### **SERVICE BULLETIN**

Transmittal of Revision 1 to Service Bulletin V2500-ENG-75-0029

AIR - VARIABLE STATOR VANE ACTUATOR - INTRODUCTION OF A LINEAR VARIABLE DIFFERENTIAL TRANSFORMER (LVDT) WITH IMPROVED EXTERNAL SEALING

ENGINE COMPRESSOR CONTROL - VARIABLE STATOR VANE ACTUATOR. INTRODUCTION OF LINEAR VARIABLE DIFFERENTIAL TRANSFORMER (LVDT), WITH IMPROVED EXTERNAL SEALING.

Removal and Installation of the LVDT 1685-75-003
Figure 1
Page 5 of 14

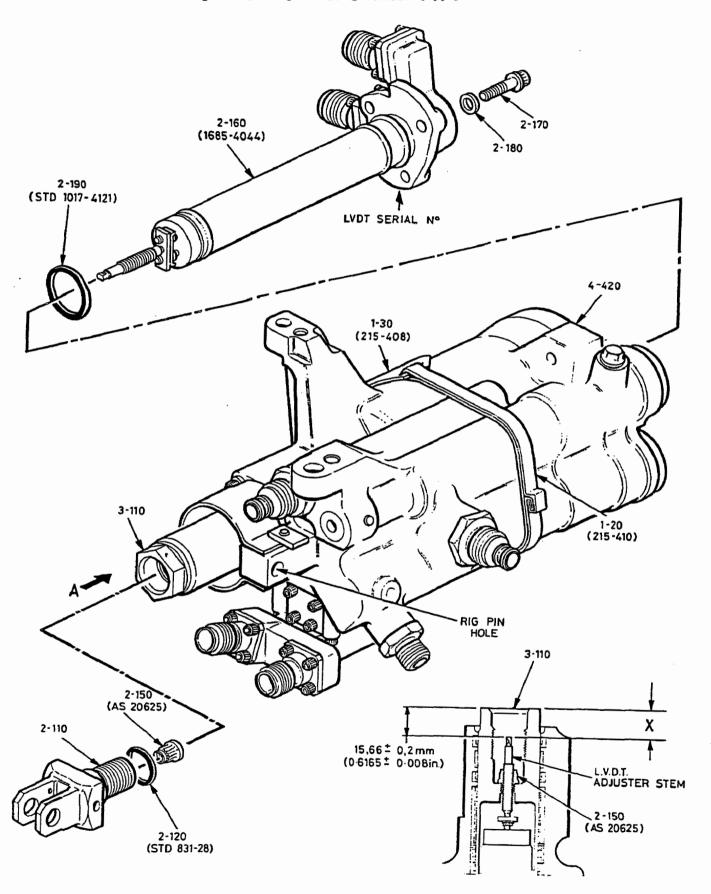
The current standard of Linear Variable Differential Transformer (LVDT), (in the Variable Stator Vane Actuator Unit), is not proof against the entrance of fuel. Entrance of fuel can cause the Eccosil potting compound to swell which can move the termination wires and the magnetic shield. This condition can result in short circuit(s) and a double lane electrical failure.

- (1) This Service Bulletin (Modification) introduces an LVDT with improved external sealing and which is proof against the entrance of fuel.
- (2) This Service Bulletin is in two parts. Part 1 is to accomplish this Service Bulletin at the Operator's facility (Contractor Working Party). Part 2 is to accomplish this Service Bulletin by unit replacement.

- (3) Refer to 75-32-41 and Figure 1 of this Service Bulletin and release the label retaining strap (1-20); remove the label retaining strap (1-20) and the data plate (1-30) from the VSVA.

- (a) Extend the ram piston (piston assembly) (3-110) by hand to the fully extended position. Remove the locking wire securing the fork end (2-110) to the ram piston (3-110). Use the reaction tool (of tool A43221), to hold the ram piston and unscrew the fork end with the torque adapter.

- (b) Remove the fork end (2-110) together with the toroidal sealing ring (2-120) from the ram piston (3-110). Remove the toroidal sealing ring (2-120) from the fork end (2-110); discard the toroidal sealing ring.

- (c) Unscrew and remove the self-locking nut (2-150) from the adjuster stem of the LVDT (2-160). Use the adjusting tool A43222 to hold the LVDT adjuster stem while the self-locking nut (2-150) is unscrewed at the same time. Discard the self-locking nut (2-150).

- (d) Unscrew the LVDT adjuster stem from the ram piston (3-110) (clockwise when viewed from arrow A); use the adjuster part of the tool A43222.
- (e) Unscrew and remove the three machine bolts (2-170) and the countersunk washers (2-180); these components secure the LVDT (2-160) to the body assembly (4-420).
- (f) Remove the LVDT (2-160) from the body assembly (4-420). Remove the toroidal sealing ring (2-190/2-190A) from the LVDT; discard the toroidal sealing ring.
- (g) Attach a label to the removed LVDT; the label must contain this data:

- (e) Position the ram piston (3-110) to the mid stroke position. Extend the stem of the LVDT and install the LVDT to the body assembly (4-420), through the ram piston (piston assembly) (3-110); make sure that the LVDT adjuster stem engages the hole in the shoulder of the ram piston (3-110).

- (f) Use the adjuster part of the tool A43222 to screw the adjuster stem of the LVDT into the shoulder of the ram piston (3-110) (counterclockwise when viewed from arrow A). Make sure that the thread of the adjuster stem is fully engaged.

- (g) Align the three holes in the flange of the LVDT with the three holes in the LVDT housing (body assembly (4-420)). Install the three flat, countersunk washers (2-180) and the three machine bolts (2-170) to secure the LVDT.

- (h) Check, when the bolts are tightened, that there is a minimum of 0,23 Nm (2 lbf.in.) inbuilt torque in each of the inserts. If the inbuilt torque is less than this figure, reject the unit for Repair. Torque tighten the machine bolts to 4,5 Nm (40 lbf.in.).

- (i) Use the adjuster part of the tool A43222 to set the LVDT adjuster stem to a dimension of 15,66 ± 0,2 mm (0.6165 ± 0.008 in.) from the end of the piston as shown. Check with a vernier depth gauge.

- (d) Measure the depth of the adjuster stem from the end face of the ram piston (3-110) (dimension X, Figure 1). Write this dimension down in case no further adjustment is required.

LVDT Output Voltage Checks Figure 2

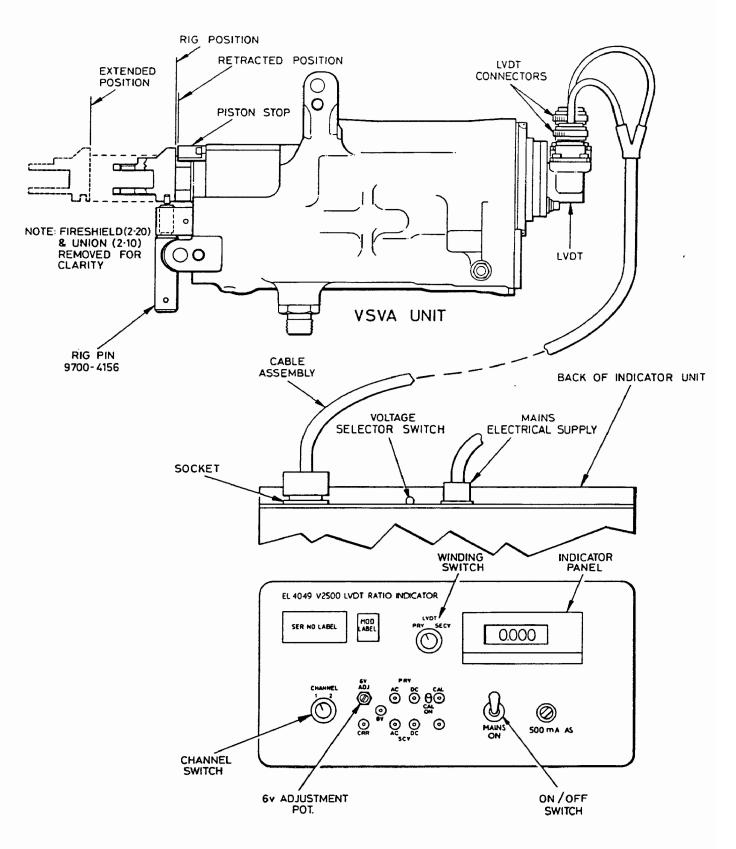
- (5) Check the local electrical supply voltage (120v or 240v). Refer to Figure 2 and set the voltage selector switch on the LVDT indicator unit EL4049, to equal the supply voltage. Connect the indicator unit to the mains supply and switch the on/off switch to the ON (down) position.

- (9) Check the LVDT adjustment, Figure 2.
  - (a) Connect the cable assembly to the socket on the LVDT indicator unit (EL4049), and the Channel 1 and Channel 2 connectors on the VSVA unit.

- (f) Get the LVDT Supplier's Certificate and compare the Channel 1 and Channel 2 Rig Position, output voltages (as recorded), with those on the Certificate. For the LVDT to be accepted at the current setting, the voltages must be as follows:

Channel 1 output voltage must equal that stated on the Supplier's Certificate ± 0.002v.

Channel 2 output voltage must equal that stated on the Supplier's Certificate  $\pm 0.003v$ .

- (h) Repeat sub. para. (f).
- (i) Remove the rig pin 9700-4156 and move the ram piston to the fully retracted position (with the fork end against the piston stop). Check the indicated output voltage for both Channel 1 and Channel 2 at this position. The indicated output voltage is to be within the limit of 2.689v minimum and 2.736v maximum.

- (k) Repeat sub. para. (f).
- (1) Move the ram piston (3-110) to the fully extended position. Check the indicated output voltage for both Channel 1 and Channel 2 at this position. The indicated output voltage for each Channel is to be within the limit of 0.385v minimum and 0.417v maximum. If the output voltage (for either Channel), is outside of the limit, the same adjustment conditions as for sub. para. (j) apply.
